MARKET STREET SITE

HANOVER DESIGN SERVICES, P.A.
LAND SURVEYORS, ENGINEERS & LAND PLANNERS
1123 FLORAL PARKWAY
WILMINGTON, N.C. 28403
PHONE: (910) 343-8002
LICENSE # C-0597

RE: Bojangles Market Street – Wilmington
Response to Preliminary Plan staff review comments and concerns

In response to review comments finished May 7 for "Site Plan Version 1 at Bojangles Market Street" (20140190733), I would like to submit the attached revised drawings, and address the individual comments, as follows:

Site & Utilities Plan

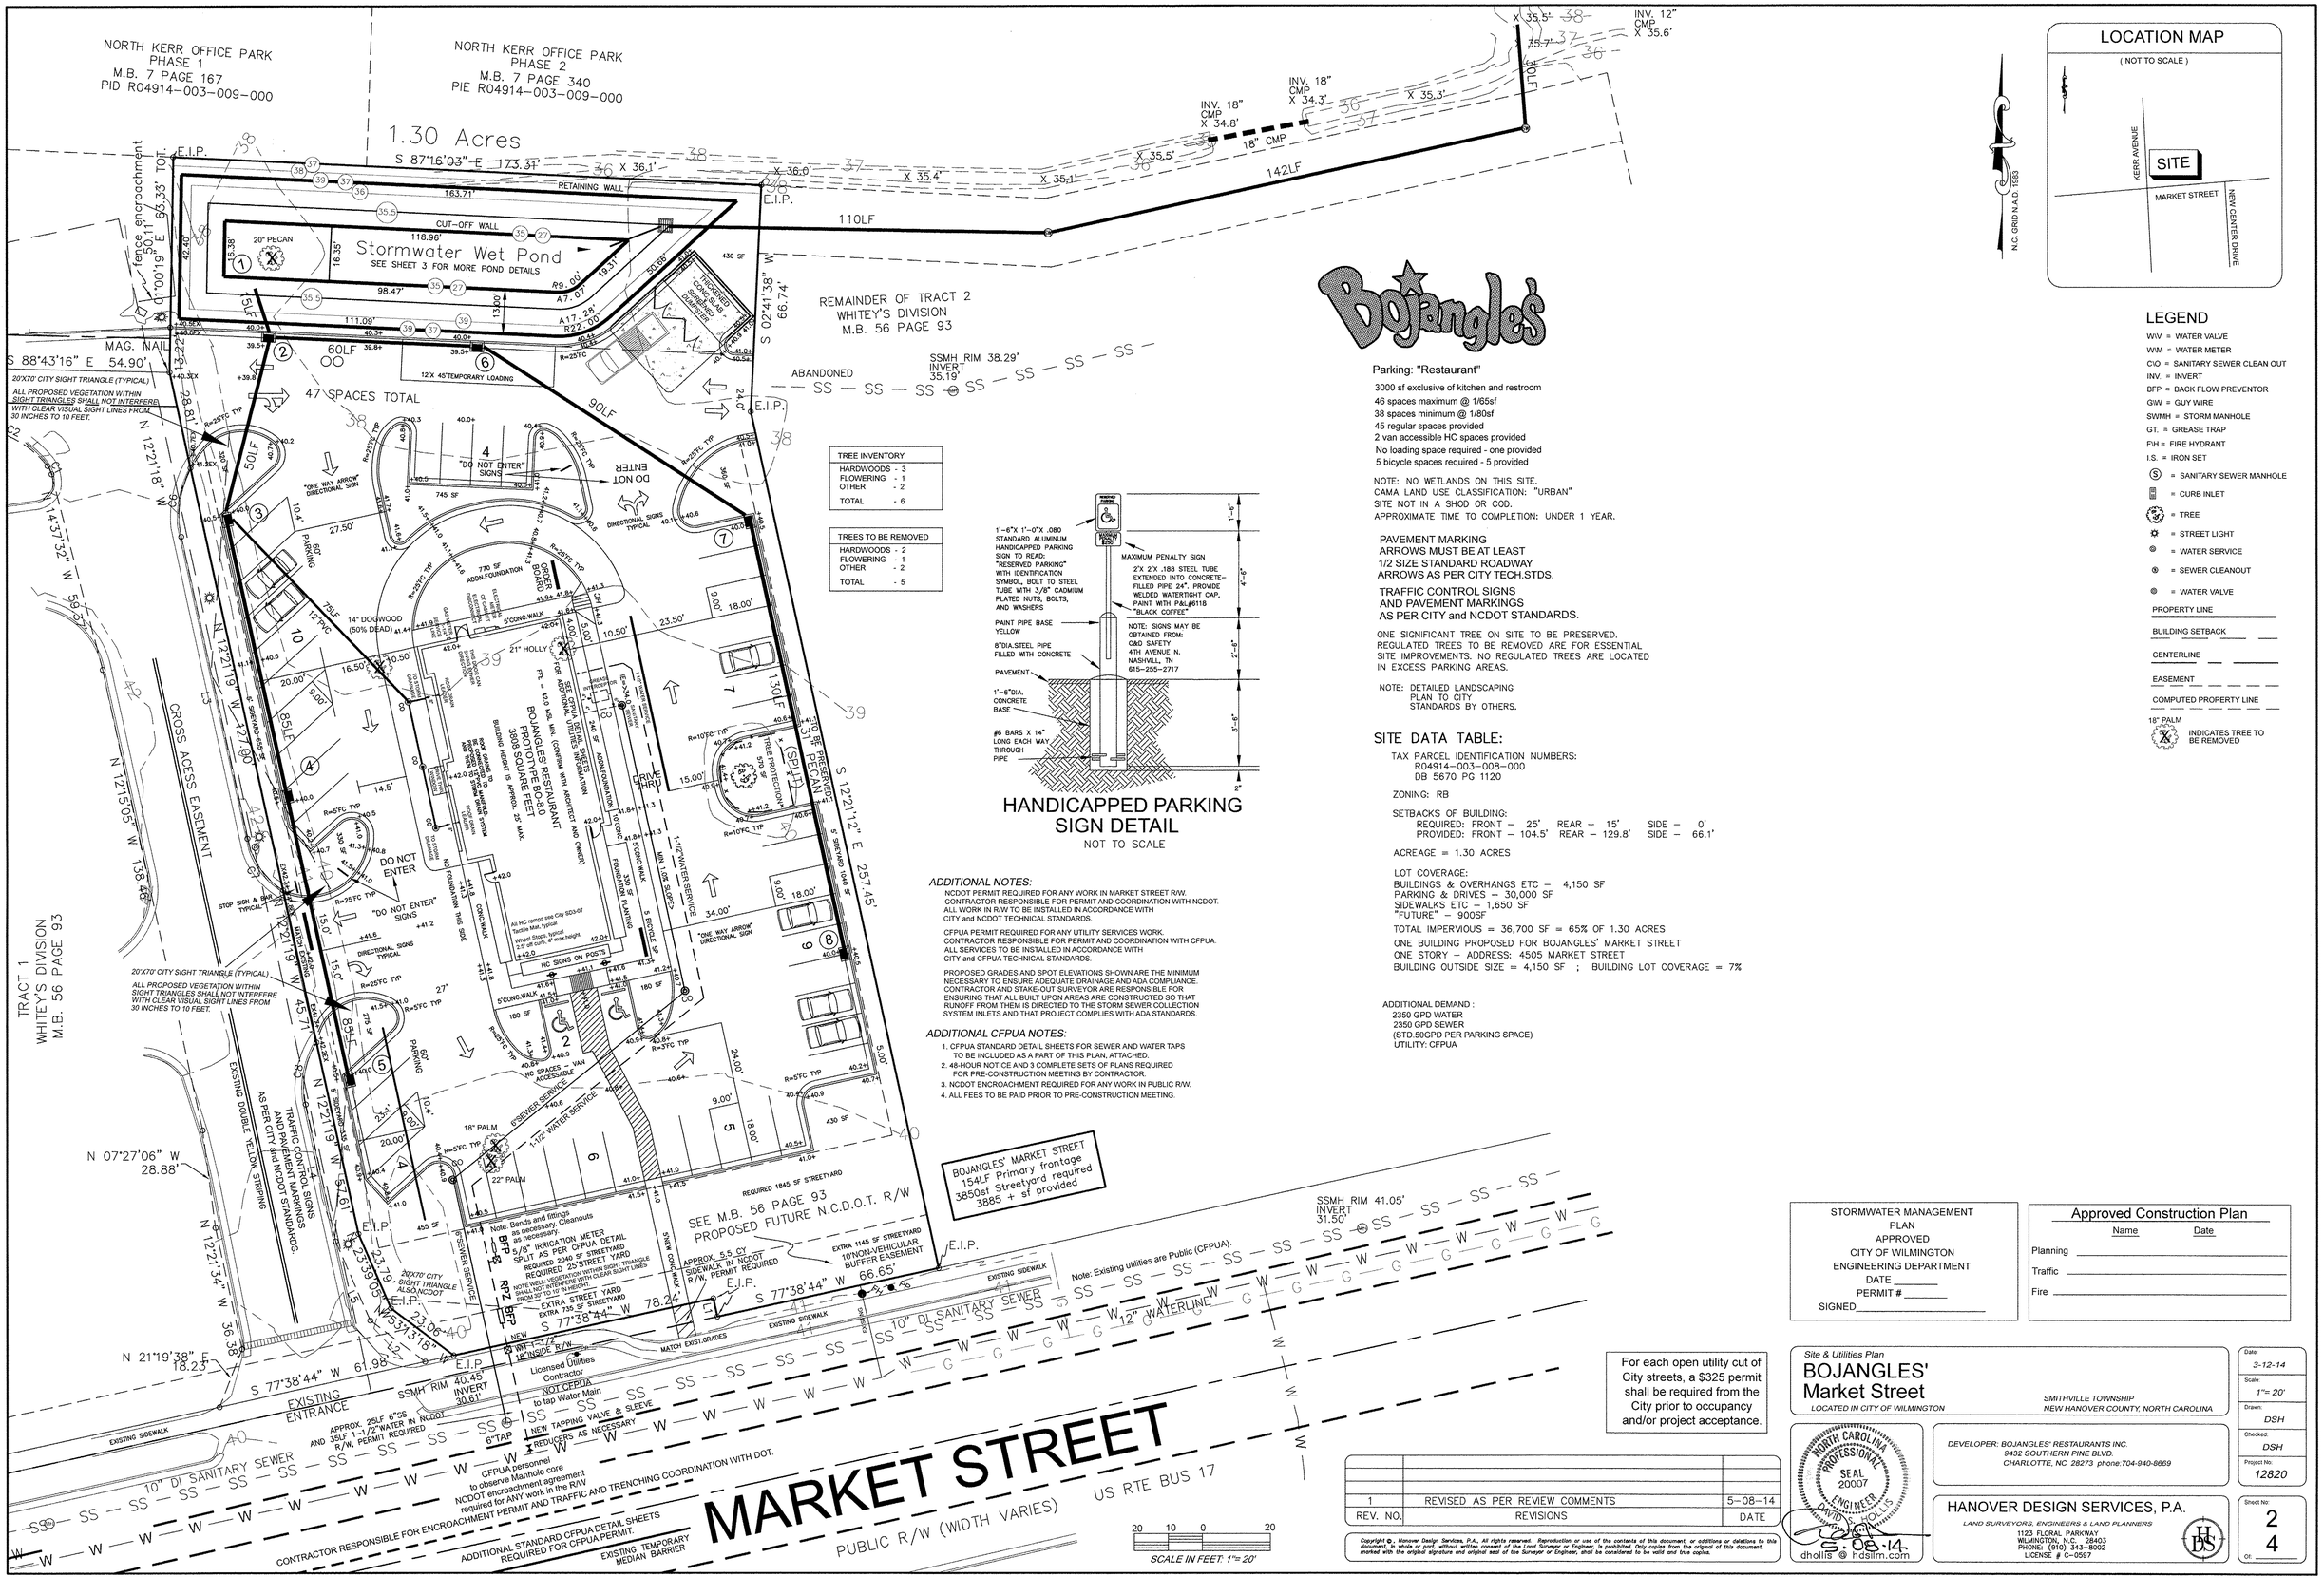
- I added the requested sight triangles at the two access points to our site from the common easement. The drives are correct in width and spot proposed elevations were shown correctly as indicated on Sheet 2.
